Comments on #SDP-26-0005 - Planning & Zoning: Site Development Plan

Application Number: #SDP-26-0005
Application Type: Site Development Plan
Date: June 29, 2026
Address: 4502 VINEYARD PINE LN, ROLESVILLE
Parcel: 1758453022

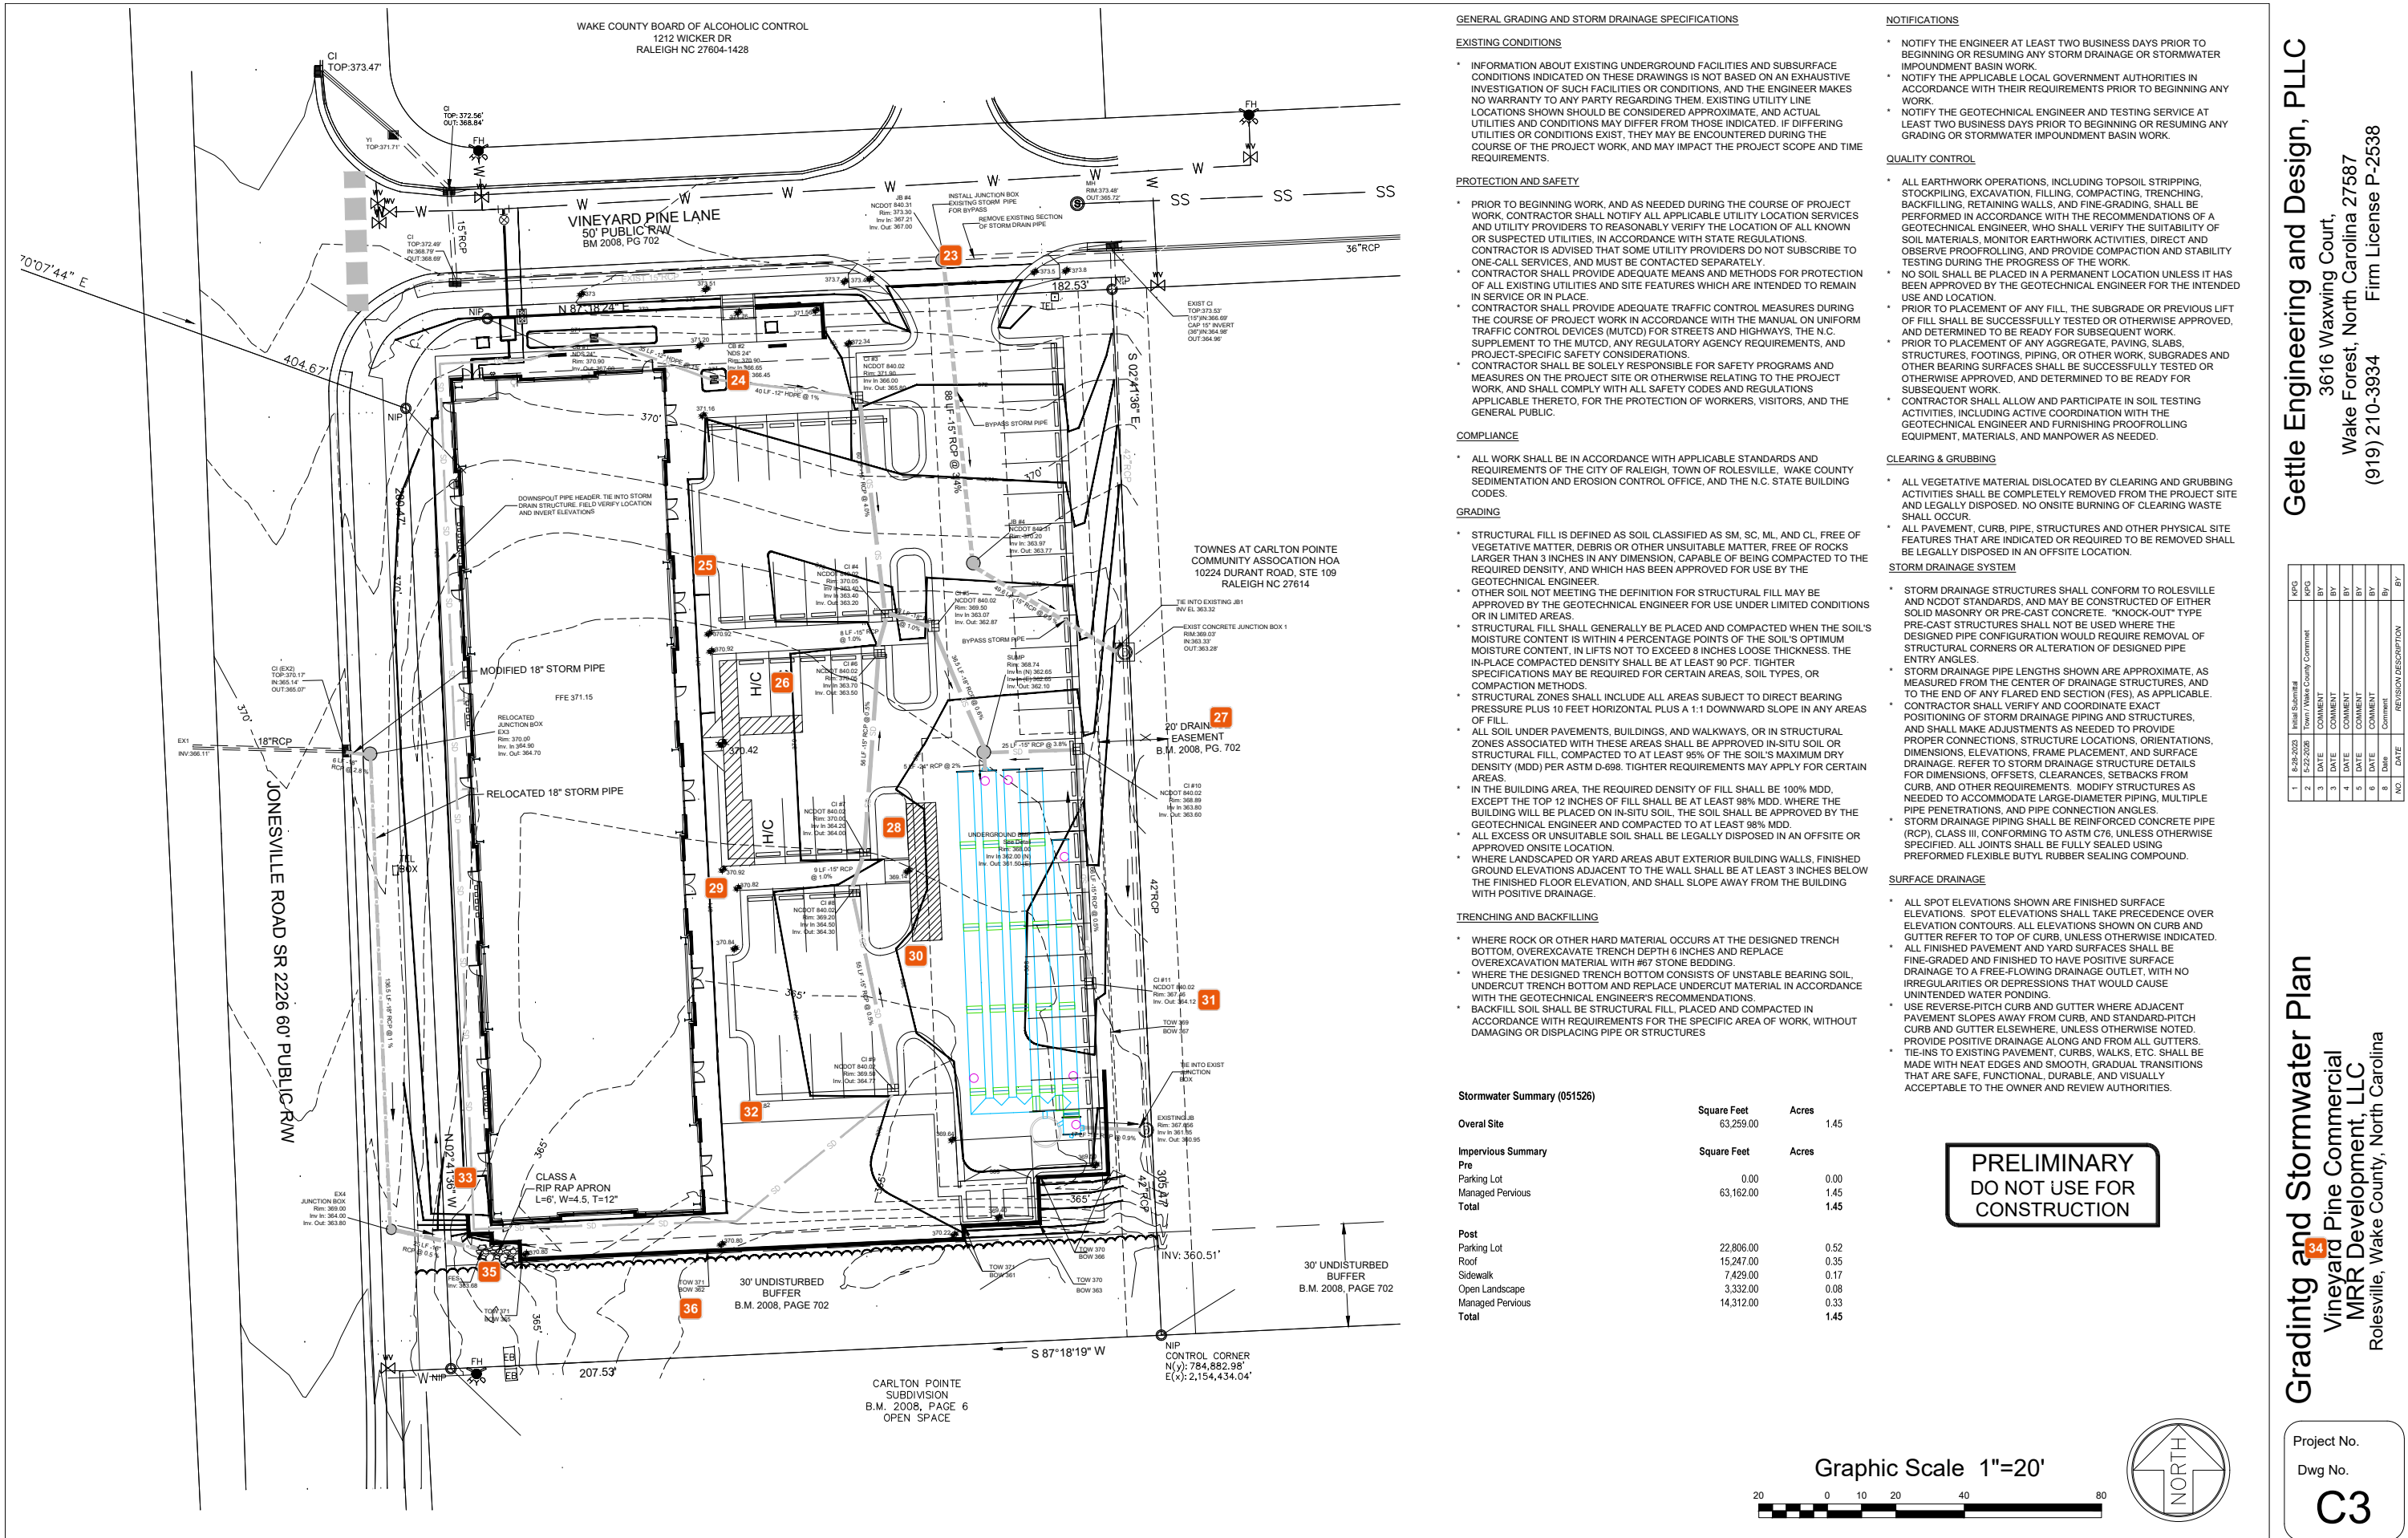
Michele Raby
Please show sign easement for entrance sign if applicable.
- 13

Stephen Wensman
The transition between the multi-use trail and the sidewalk needs to be revised so the trail transitions to concrete.
- 15

Stephen Wensman
Add curbstops for these 2 parking stalls
- 16

Stephen Wensman
Curb stops are not needed here as there is no abutting sidewalk
- 17

Tanner Hayslette
Please add a bicycle lane on Jonesville Road per the 2022 Bicycle Plan.
- 18

Jacqueline Thompson
Please include street buffer requirements per LDO Section 6.2.2.2
- 19

Michele Raby
Retaining wall may require a WC building permit.
- 20

Meredith Gruber
Please add labels on the site plan to designate pedestrian amenities as per LDO Section 6.8.4.B.2.
- 21

Rolesville SDP-23-06 (OLD)_SDP-26-0005 (GW)_Site Plan Documents 052226.pdf · Page 4

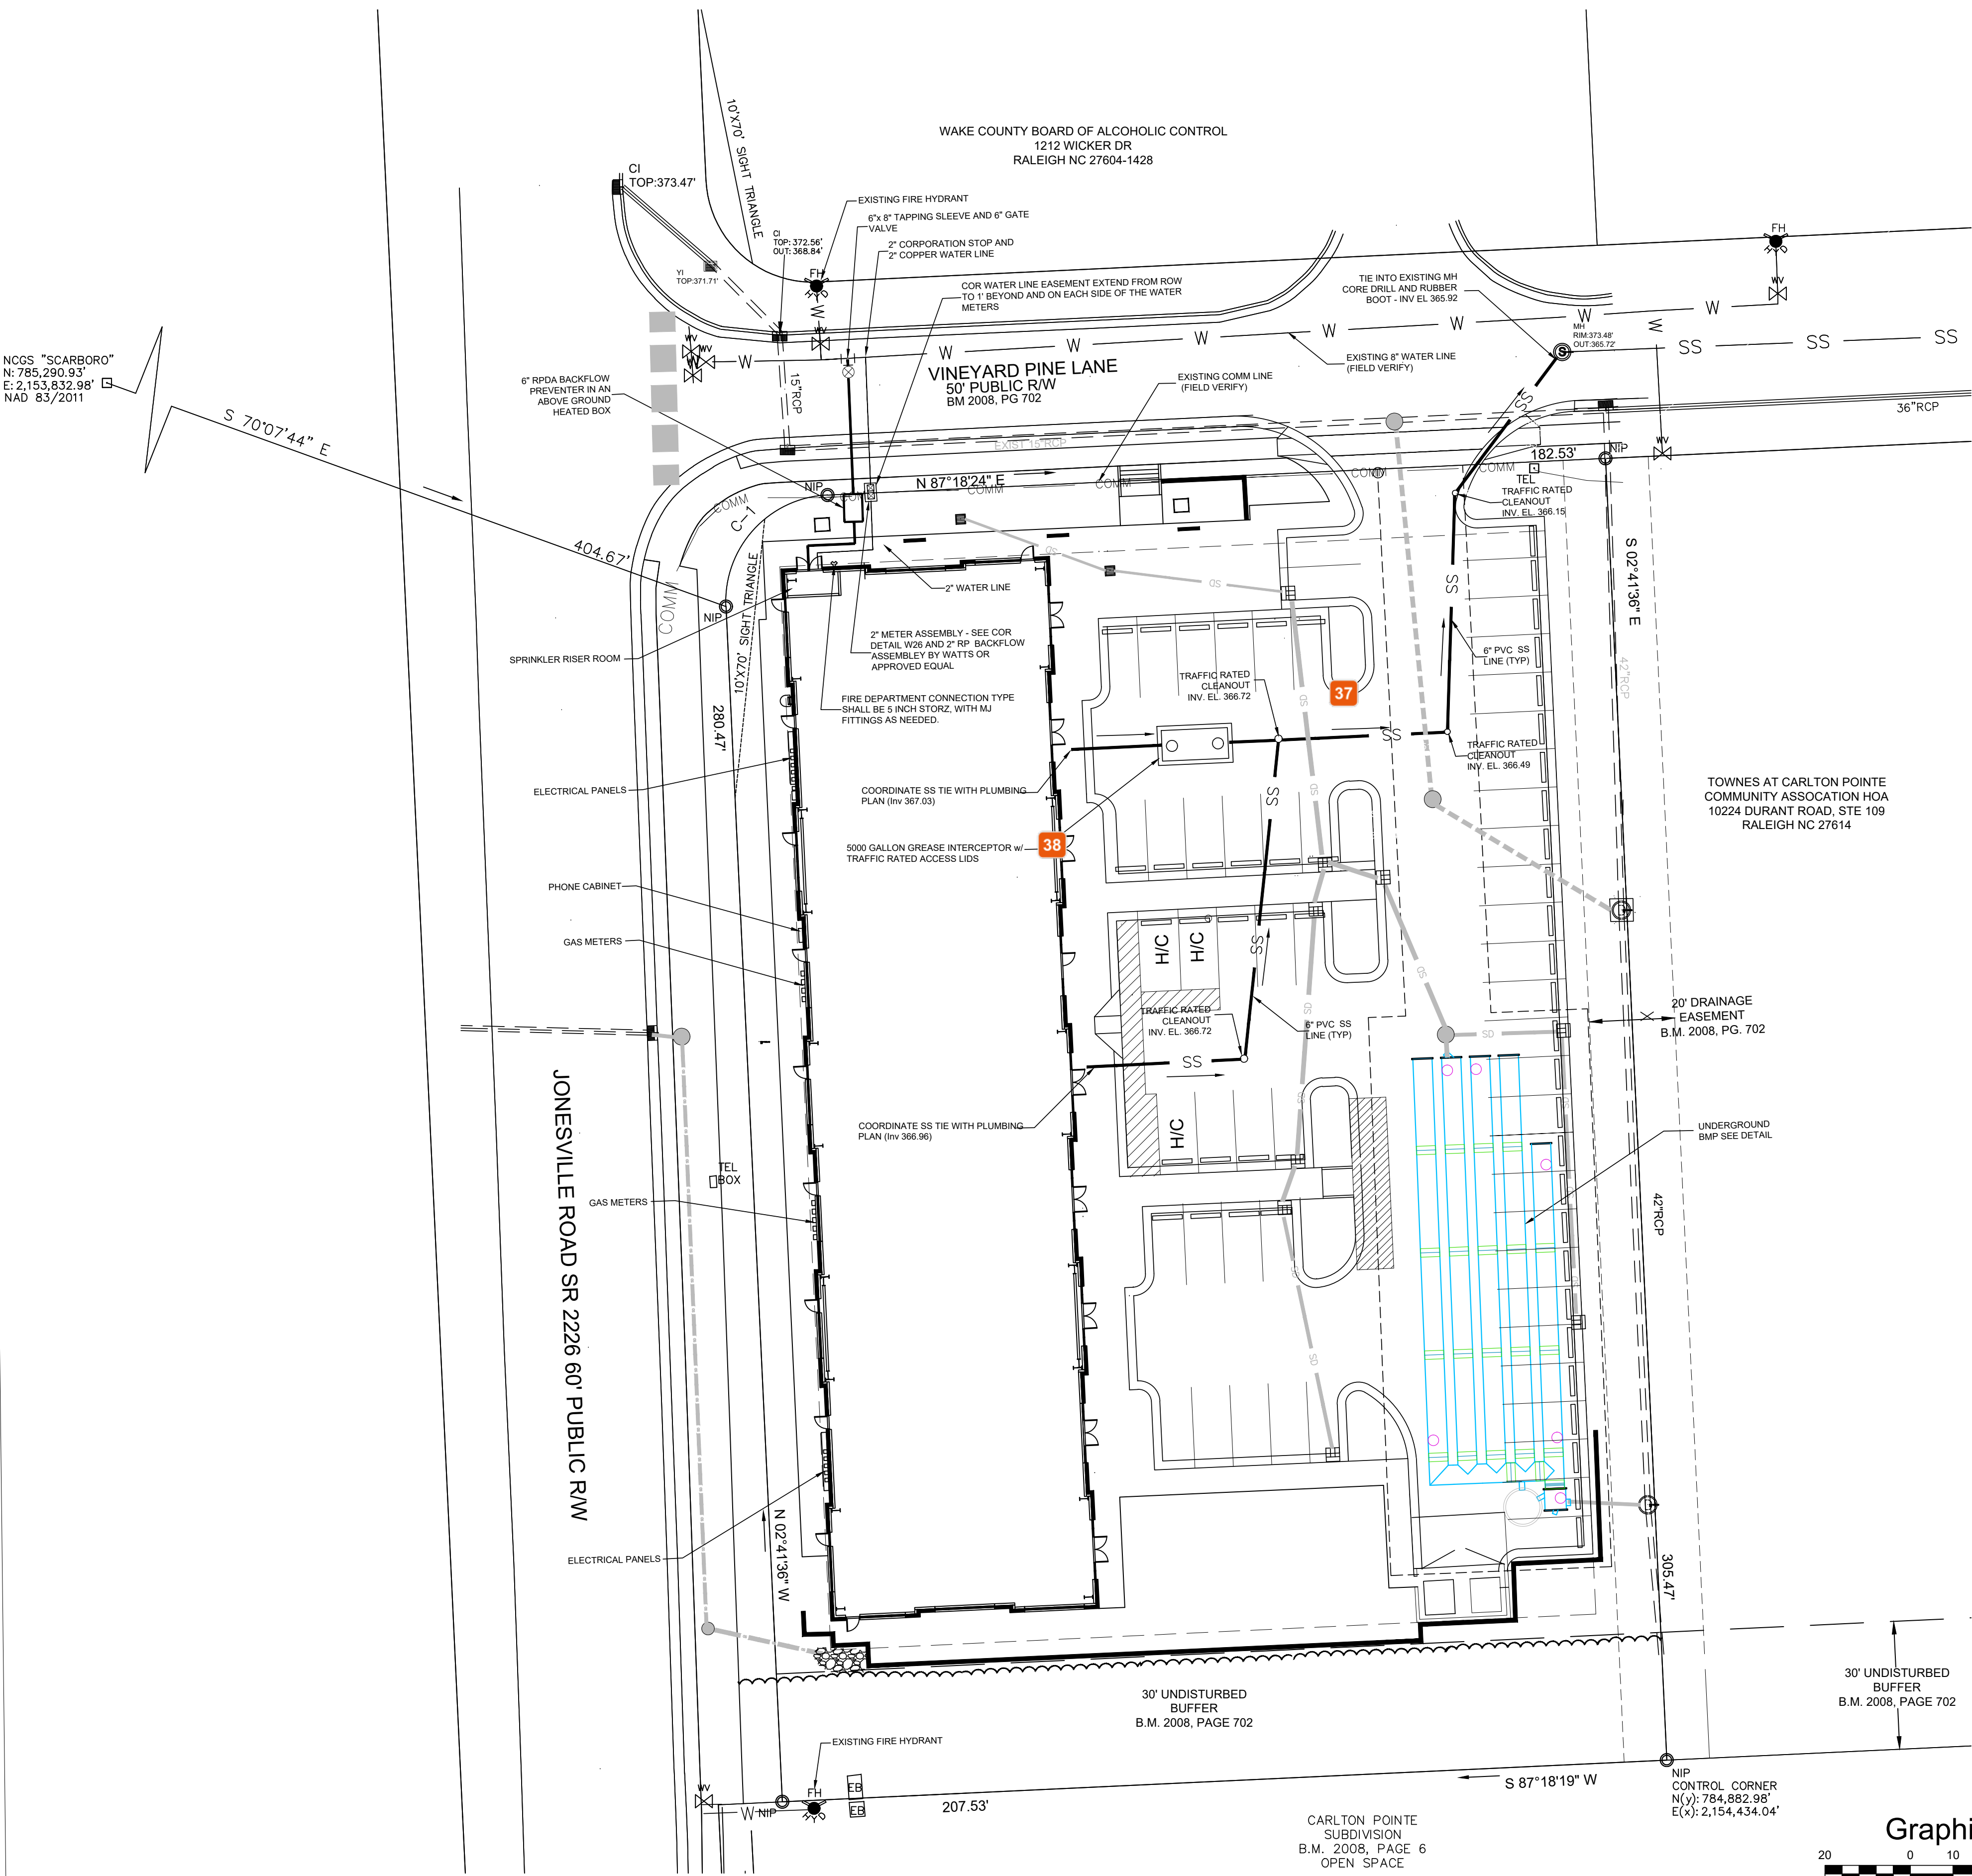
23 Jacqueline Thompson
Please clarify the intent of the storm bypass. The existing system does not seem to be in conflict, unless the proposed sewer is the concern? Is a crossing able to be done?

24 Jacqueline Thompson
There is a detail for 24" rolled curb and 24" standard curb. The labels call out 24" standard curb. Please clarify where/if the curb transitions from one style to another. Also, there is a detail for reverse pitch curb; please indicate where this curb is intended.

25 Jacqueline Thompson
Please clarify what these bold lines are going from the 371 contour to curb.

28 Jacqueline Thompson
Please include inserts or spot elevations (whichever is cleanest) to provide spot elevations at pedestrian ramps to ensure ADA compliance.

30 Jacqueline Thompson
Please adjust contour labels so they are legible.

31 Jacqueline Thompson
This TOW / BOW label doesn't appear to be pointing at a wall. Please review and adjust accordingly.

32 Jacqueline Thompson
The spot elevations appear to be on the sidewalk but not along the edges; please review the placement of the spot elevations to ensure it helps dictate the design. ADA compliance will need to be met for access and spot elevations need to be provided to ensure drainage is positive.

33 Jacqueline Thompson
Please add additional top and bottom wall elevations at the end, or provide a retaining wall design.

36 Jacqueline Thompson
Fall protection is required for walls greater than 4'. Please include a detail for the type of fall protection.
